Lower Thames Crossing

5.4.1.1 Draft Agreed Statement of Common Ground between (1) National Highways and (2) the Environment Agency (Tracked changes version)

DATE: July 2023
DEADLINE: 1

VERSION: 2.0

Plate 1: Proposed location of HRA and ecology mitigation

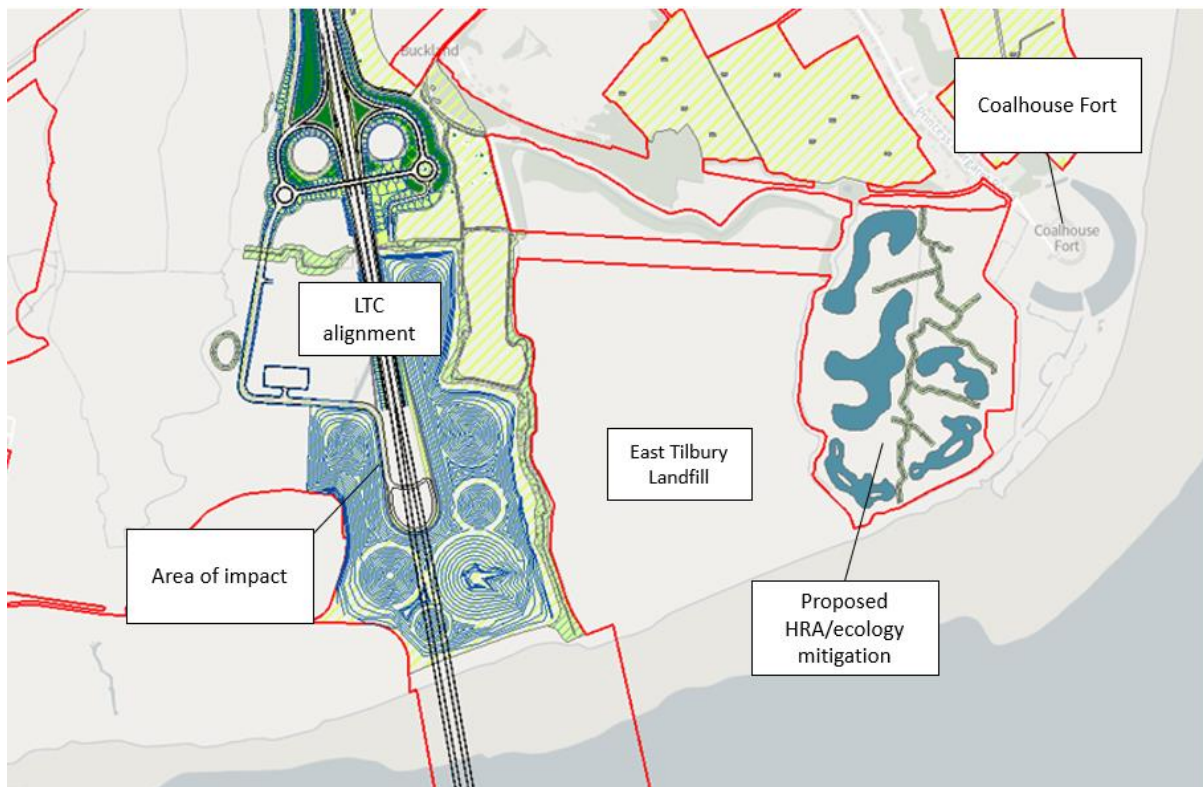
LTC's proposed Habitats Regulations Assessment (HRA) and invertebrate mitigation at Coalhouse Point requires a secure water supply. Hydrology studies indicate there is insufficient water in the natural catchment to sustain the water demand. Plate 1 presents the location and indicative design of the proposed mitigation area in the context of the LTC alignment.

- The HRA and EIA require evidence that proposed mitigation is feasible. Natural England have advised that feasibility of the mitigation will need to be presented before they would be able to agree the sufficiency of the mitigation in the SoCG, which is a DCO acceptance risk and DCO consenting risk.

Plate 2: Proposed amendments to the DCO Order Limits to provide the 50mx20-35m working space for the construction of the sluice structure. Approximate amendments to Order Limits to incorporate flood defence also highlighted.

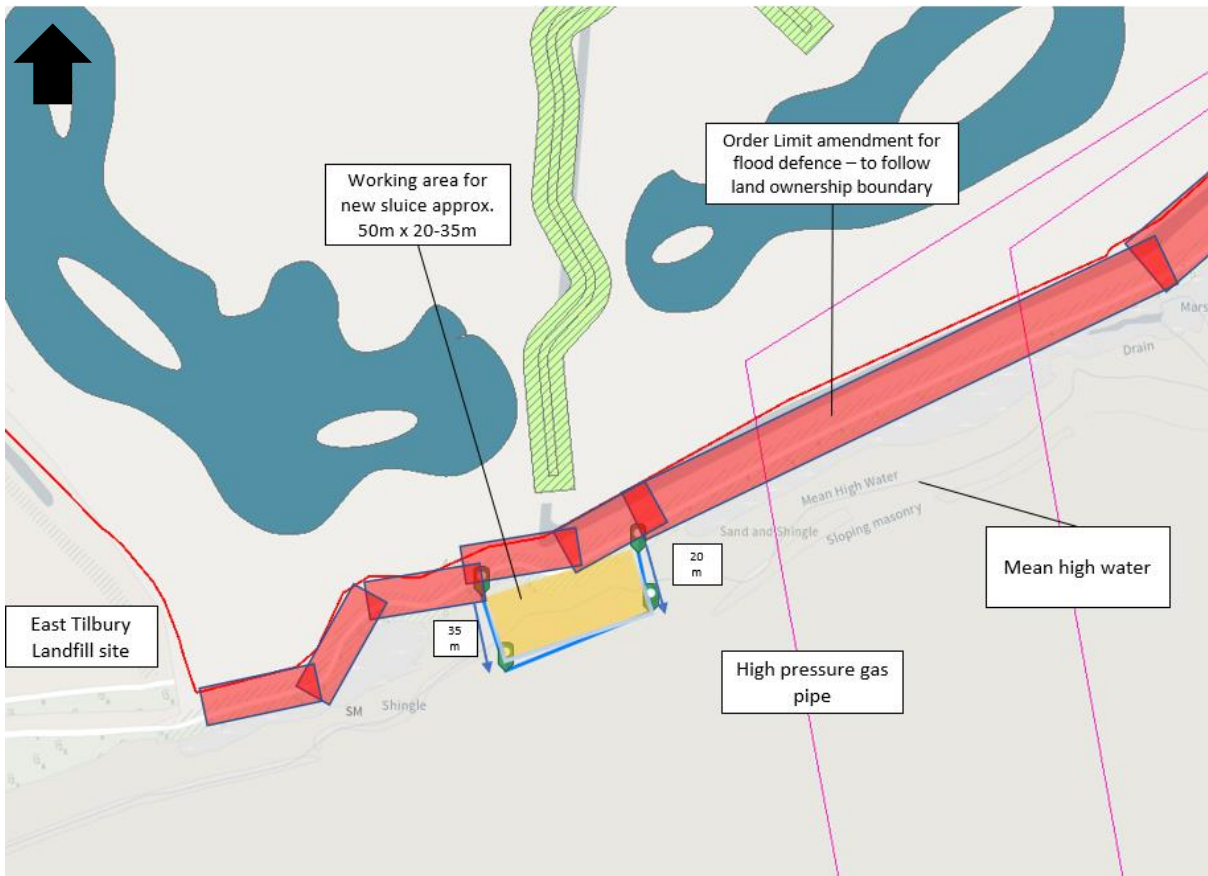
It was proposed to amend the Order Limits to incorporate the existing flood defence that is currently owned by the landowner, Mr Mott. This change was proposed irrespective of the requirement of a structure and is shown as the red area in Plate 2. Given the new structure would be limited to the footprint of the flood defence, this change would also incorporate the new structure.

Plate 3: Cross section of the existing Coalhouse Point flood defence

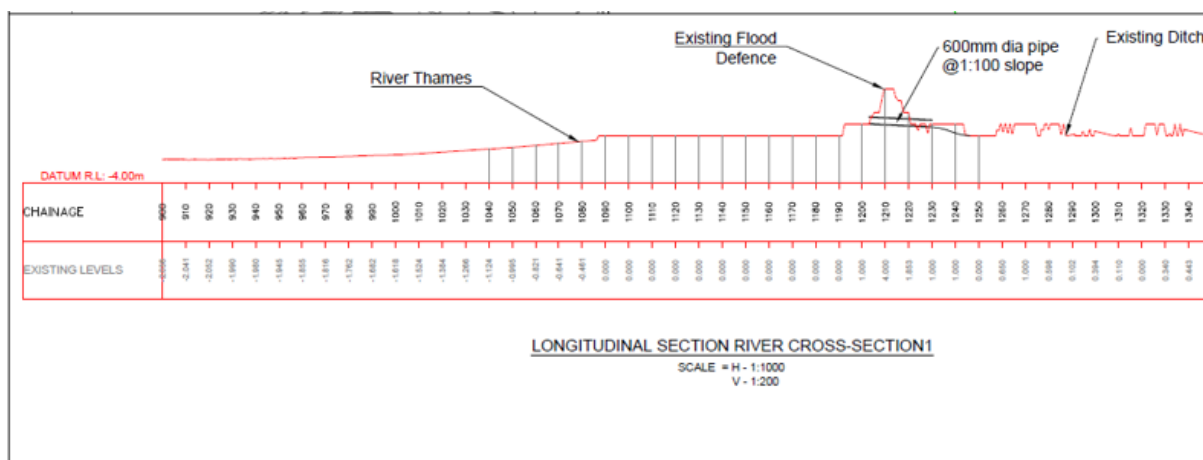
The existing ground levels and tidal regime has informed the potential location and size of the structure, relative to the existing flood bund. The crest of the flood bund sits at approximately 4.0m AoD, whilst its base on the river side is around 1.0m AoD. The existing ditch directly to the north of the flood defence is at 0.0m AoD. Plate 3 provides a cross section of the existing flood defence.

Plate 4: Mean high water spring tidal cycle at Coalhouse Point

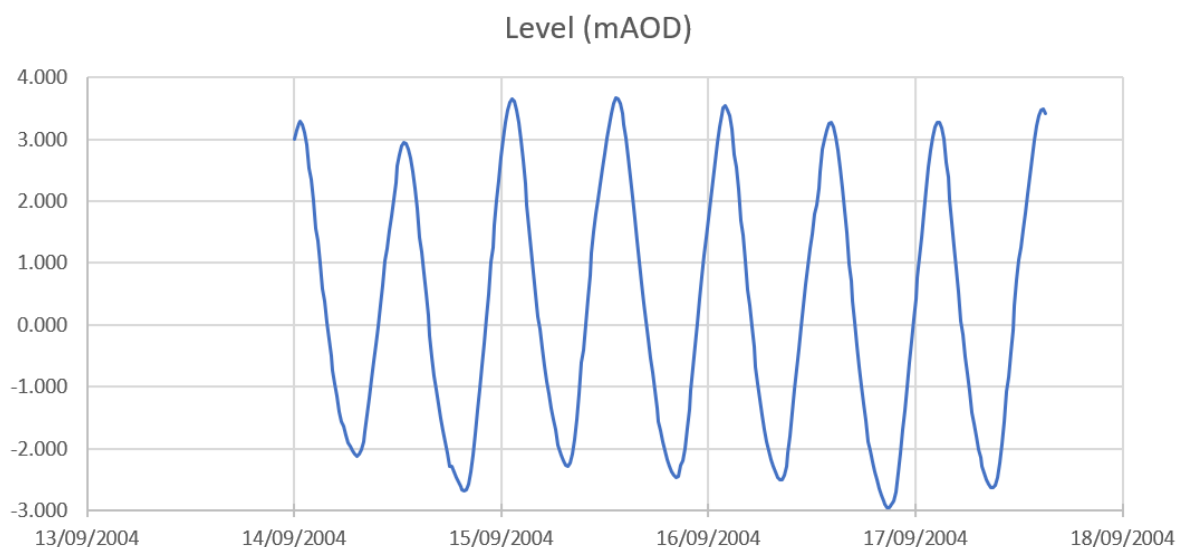
An estimate of the Mean High Water Spring tidal cycle over a three-day period was developed using TE2100 model node at East Tilbury Marshes (Plate 4). It was determined

that the Thames' water level would be greater than 2.0m AoD for 24.75 hours over the three-day period. Assuming that a 600mm diameter pipe is installed, this would be sufficient to convey water through the flood defence to meet the required water demand of the proposed mitigation area and would avoid any permanent works within the inter-tidal area. Due to the elevated position of the structure within the flood defence and its relative position in terms of overall tidal frame, it has been assumed that the risk of the structure becoming silted up is low.

Figure 1: Impact of increased defence levels on breach start and end times at Mardyke Sluice breach (based on future level for Option 1.4 in 2127)

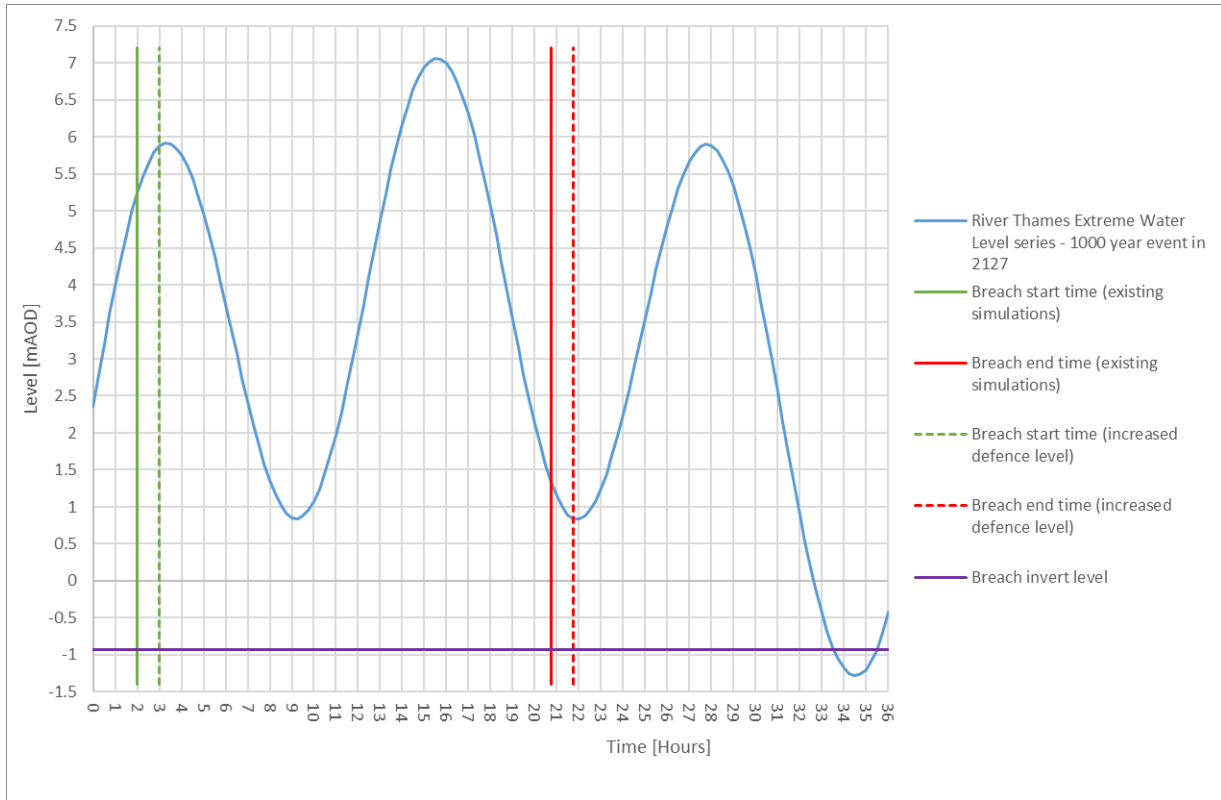
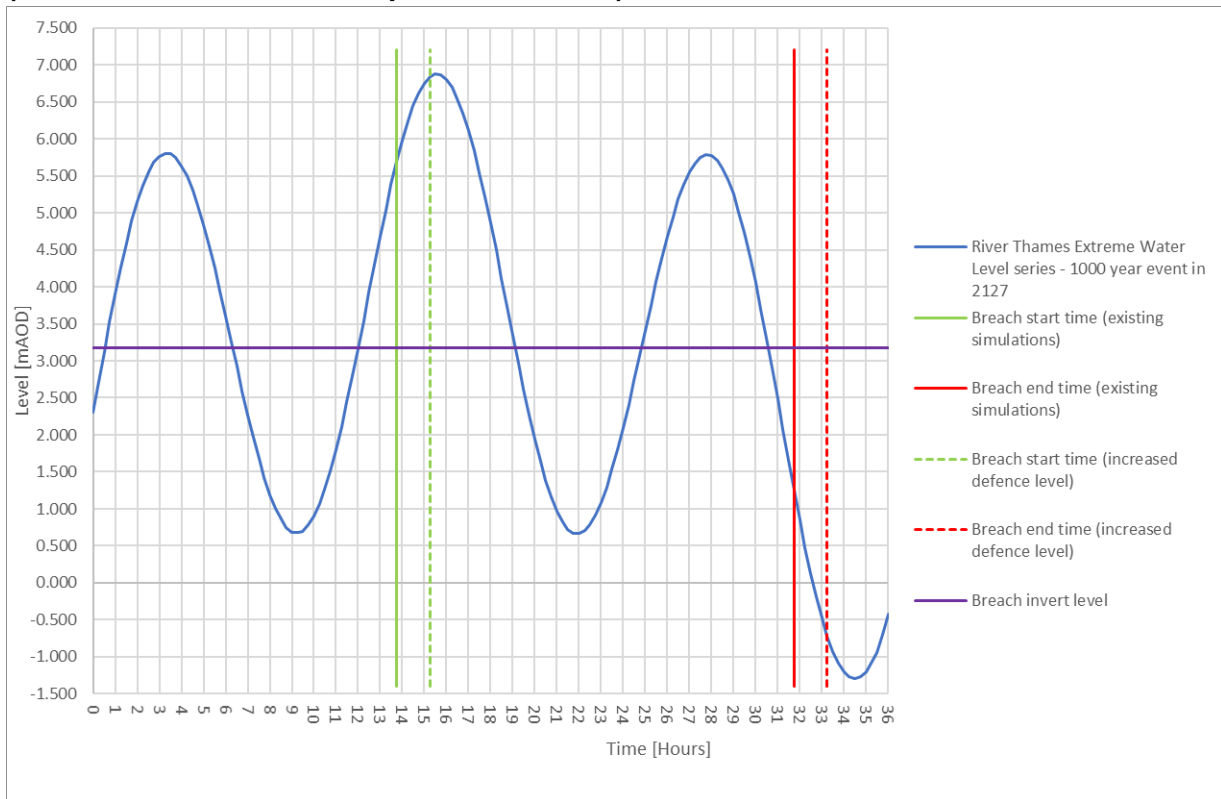
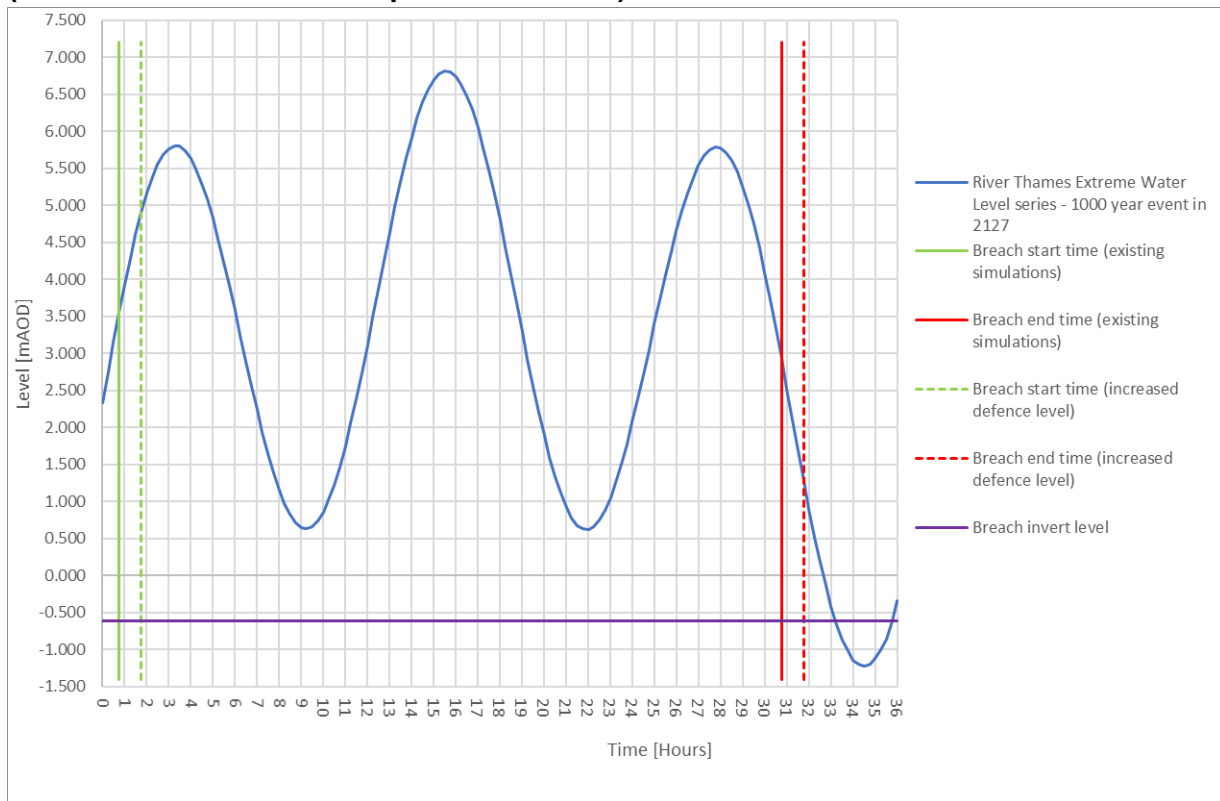
- 2.2.4 Figures 1 to 3 show the influence of increasing flood defence levels on breach start and end times for the LTC FRA breach simulations. The change in breach start and end times is shown for the highest required future defence levels (i.e. the future defence levels that are most different to those assumed in the LTC FRA breach simulations, highlighted in orange in Table 2).

2.2.5 Figures 1 to 3 show that for all LTC FRA breach locations, applying higher flood defence levels results in a delay in the start and end times of simulated breaches. An inspection of Figures 1 to 3 indicates that the reduction in initial breach flows resulting from increased defence levels (due to a delayed start) would exceed the gain in breach flows at the end of the simulated breach event, as River Thames flood levels are higher at the start of simulated breach events than at the end of the events (and for TIL005 there would be no gain in breach flows at the end of the simulated breach event, as River Thames levels would be below the TIL005 breach invert level at the end of the simulated beach). There would therefore be an overall reduction in simulated breach flood volume as a result of increasing flood defence levels.

2.2.6 The LTC FRA breach simulation results show the nearest parts of the LTC Project within TIL005 and TIL006 breach event flood extents are approximately 2km and 0.8km respectively from the breach locations, with simulated peak velocities significantly lower than at the breach locations. The influence of an increase in flood defence levels on breach impacts at the LTC Project would therefore be dominated by total breach volume (i.e. breach flood extent and level).
